Re: Change orders 8, 9 and 10. Request for your Approval.

CHANGE ORDER

PROJECT: Courthouse Square
(name, address) 555 Court Street NE
Salem, Oregon 97301

CHANGE ORDER NUMBER: 8

PROJECT NAME COURTHOUSE SR CALCULATED BY T³ DATE 8/4/99
 PROJECT NO. 4090300104 CHECKED BY _____ DATE _____
 SUBJECT POUR #3 GROUND FLOOR SHEET NO. 1 OF 1

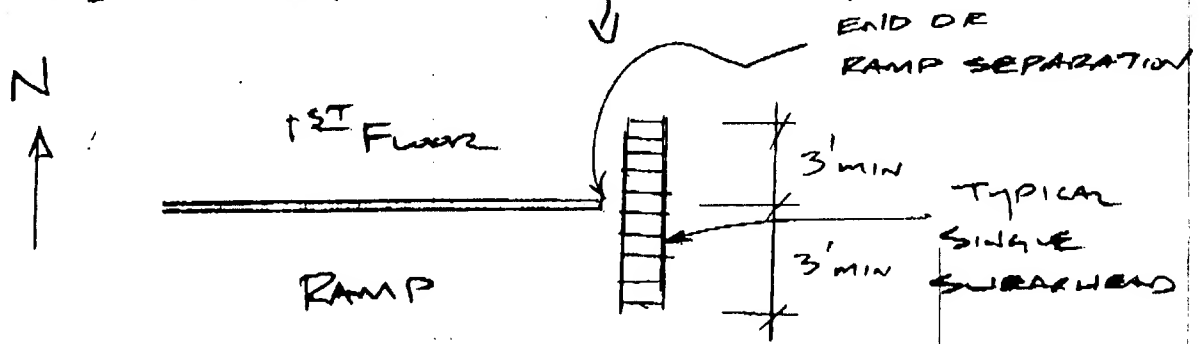
RE: POUR #3 REINFORCING REVIEW & SITE VISIT
 (AT Ground Floor FAV East End)

1) INSTALL #5 EPOXY DOWELS @ 12" OC BETWEEN
 THE RAMP & SHEARWALL. PROVIDE 12" EMBED
 IN THE WALLS, LAP 36" INTO THE
 CENTER OF THE SLAB.

Provide additional epoxy dowels and rebar shear head per attached fax from Tim Terich dated 8/4/99
